**ADDENDUM 1**  
**to**  
**DIGITAL CLOCK DISTRIBUTOR**  
**500 SERIES**  
**CARD INFORMATION**

**1.001** This is an addendum to Issue 2 of Telecom Solutions' Digital Clock Distributor 500 Series Card Information section (part number 097-44018-04) which is part of the TL1 User's Guide (997-44018-15). Place this addendum in front of Issue 2 of 097-44018-04.

## DIGITAL CLOCK DISTRIBUTOR

Figure 1. MIS Card Switch

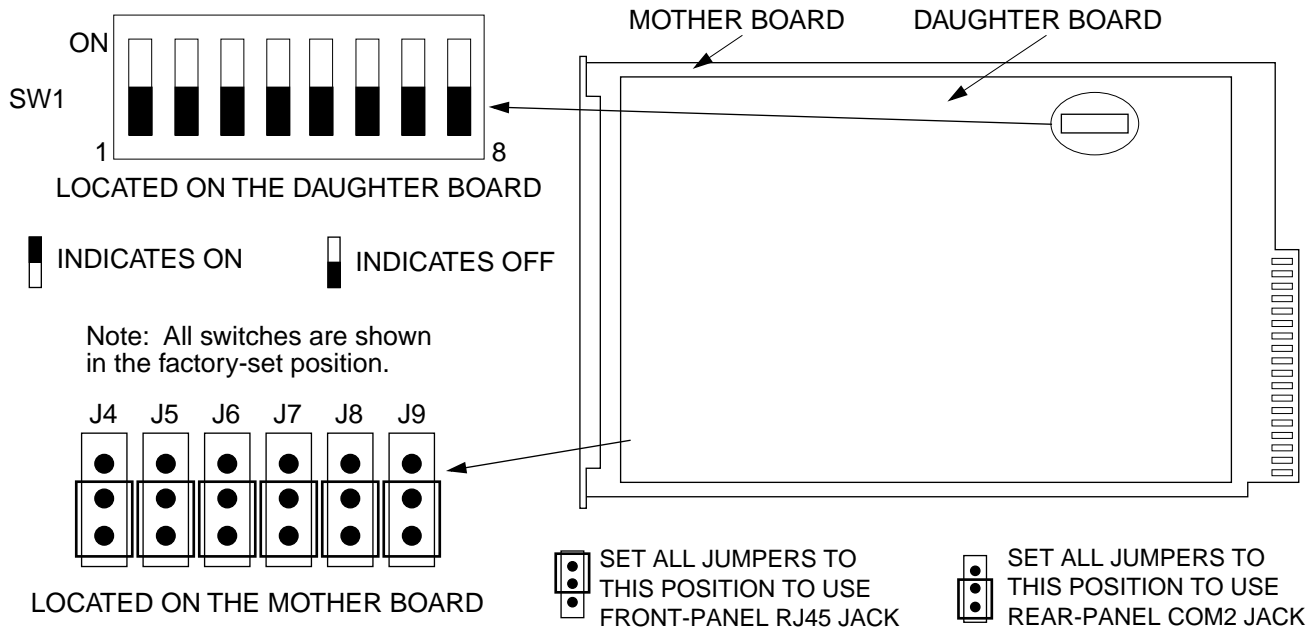
**1.02** This practice has been reissued to modify the definition of section 5 of switch SW1 on the MIS card. The changed area is marked by a change bar.

SW1 Section	Position	Description	Factory Setting
1	On	1200 baud	—
	Off	9600 baud	X
2 and 3	2=on, 3=any	Odd parity	—
	2=off, 3=on	Even parity	—
	2=off, 3=off	No parity	X
4	On	Password protection enabled	—
	Off	Password protection disabled	X
5	On	Causes an automatic download of the card configuration database from the MIS card to any other card whose database does not match the MIS database for that slot, such as: after a shelf power cycle, replacement of a card with the same card type, or replacement of the MIS card	—
	Off	Disables automatic database download	X
6	On	Factory set. Do not change.	X
7	On	Installed in an Expansion or Remote Shelf	—
	Off	Installed in a Master Shelf	X
8	Off	Normal operation (do not change)	X
